# UNITED STATES PATENT AND TRADEMARK OFFICE

# Office Action Summary

10/613,793

OOSTERHOUSE, ROLAND R.

**Fig. 2**

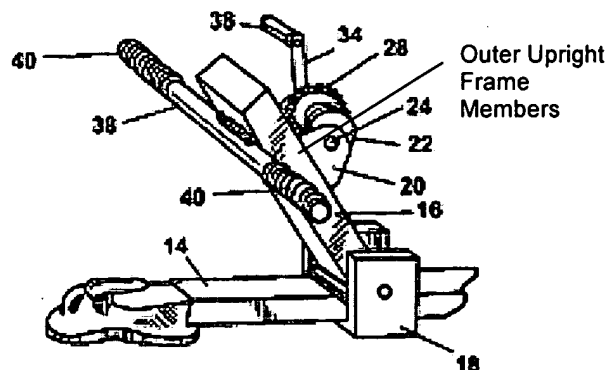
further in view of Kamminga (US 6,361,060). As noted above Ostrand and Kelly disclose a dolly with all the claims and limitations as recited in claims 1-5. Ostrand and Kelly do not teach a winch mounted on an upright member, or handle formed by an upright member for manual transport of the dolly. Kamminga discloses a dolly 10, base frame 42, upright member 16, winch 20, upright outer frame members as shown below, and a horizontal frame member 38 above the winch 20 to form a handle. Referring to FIG. 2 as shown below Kamminga teaches that a winch/handle combination allows positioning of a dolly under a watercraft such that a winch can charge a watercraft on to a dolly. Col. 1, Ins. 25-30. Therefore, it would have been obvious to one of ordinary skill in the art at the time the invention was made to add a winch and handle to a dolly of Ostrand and Kelly, as per the teachings of Kamminga, such that a dolly may be positioned under a watercraft for subsequent winching on to a dolly.

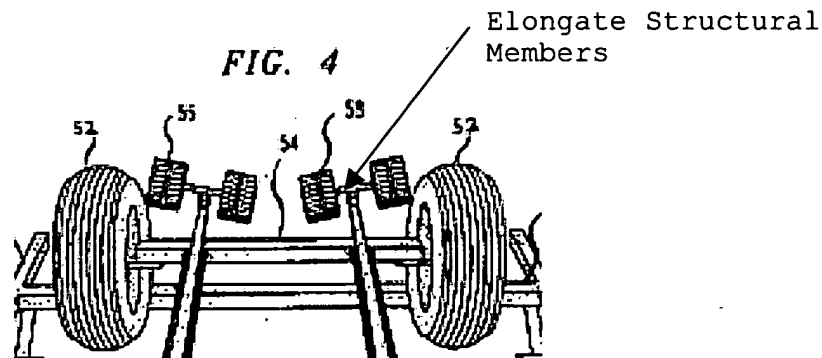
With respect to claim 17, as noted above Urbank, Ostrand and Kelly recite claims 13-16. Referring to FIG. 4 Urbank discloses elongated structural members positioned between bunks 63,64. [See figure below.] It is noted that Urbank does not limit the elongate structural members to between bunks 63,64.
